# Access Compliance Report

## Public Rights-of-Way

### (Curb Ramps)

Intersection ID: 28932	Main Street: GIBBONS_LINK_RD	Cross Street: BRANDIE_GLEN_RD	Location: W
ADA ID: D29957D819E3	Ramp Type: Directional1	Initial Pass/Fail: Fail	Overall Compliance: No
			Severity Score: 33.75

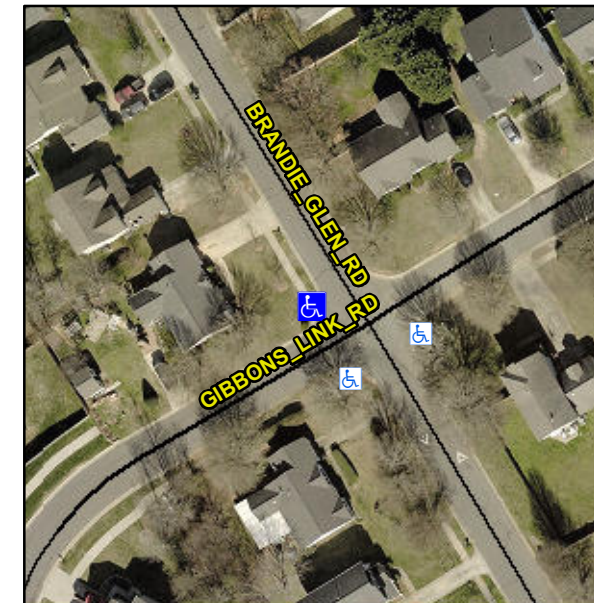
**R304.5.1, R304.2.2**

Compliance	Description	Data	Compliance	Description	Data
N/A	Ramp Length (in)	21.0	N/A	Grade Break?	N/A
No	Ramp Width (in)	47.5	N/A	Grade Break Slope (%)	0.0
No	Ramp Slope (%)	15.1	N/A	Grade Break XSlope (%)	0.0
Yes	Ramp XSlope (%)	0.8			
N/A	Flare Type LT	N/A	N/A	Flare Type RT	N/A
N/A	Flare Slope LT (%)	N/A	N/A	Flare Slope RT (%)	0.0
N/A	Flare Traversable LT?	N/A	N/A	Flare Traversable RT?	N/A
N/A	Landing Length (in)	0.0	N/A	DWS Provided?	N/A
N/A	Landing Width (in)	0.0	N/A	DWS Contrast?	N/A
N/A	Landing Slope (%)	0.0	N/A	DWS Length (in)	N/A
N/A	Landing X Slope (%)	0.0	N/A	DWS Full Width?	N/A
N/A	Landing Curb? (Y/N)	N/A	N/A	DWS Offset LT (in)	N/A
N/A	Shared Landing?	N/A	N/A	DWS Offset RT (in)	N/A
N/A	Gutter Ponding?	0.0	N/A	Gutter Slope (%)	N/A
N/A	Gutter Lip Ht (in)	0.0	N/A	Gutter X Slope (%)	N/A
N/A	Painted X Walk1?	No		Road Slope (%)	1.4
	X Walk 1 Direction	To SE		Road X Slope (%)	2.9
	X Walk 1 Width (in)	N/A		Clear Space?	N/A

**Remove & Replace Entire Ramp.**
